ADDENDUM NUMBER A2

DATE: April 20, 2011

PROJECT: NorShor Theatre
Reroofing of the Orpheum Building
Duluth, MN

ASK-1

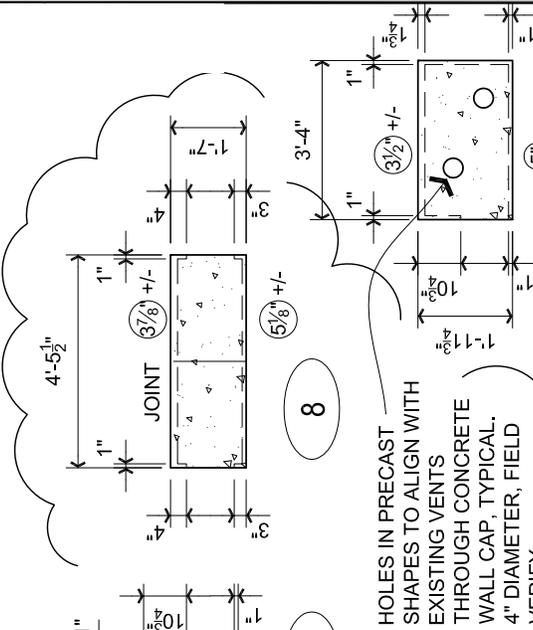
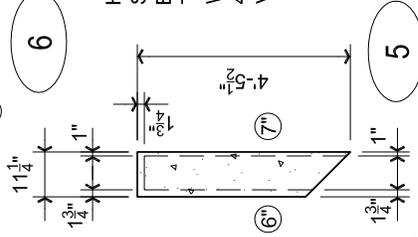
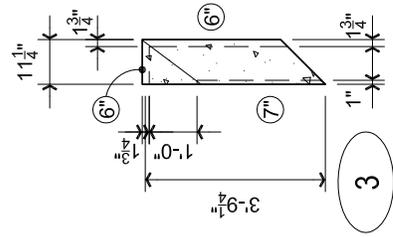
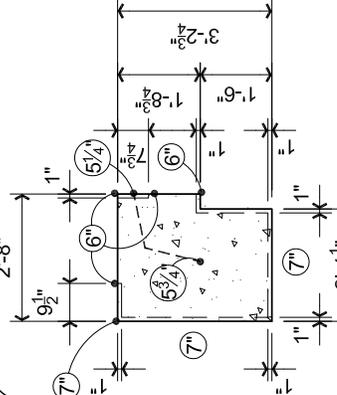
- 17. Attached ASK-1 revises D1 Precast Concrete Shapes, delete the shapes on D1/A200 which correspond to the numerical designation and are clouded on ASK-1 and replace the shapes on D1/A200 with the clouded corresponding shapes on ASK-1.

Holes in precast shapes to align with existing vents through concrete wall cap, typical, 4" diameter, field verify.

NOTE: PROVIDE SLOPE FOR DRAINING TO NORTHEAST CORNER OF SHAPE ALONG HEAVY DASHED LINE
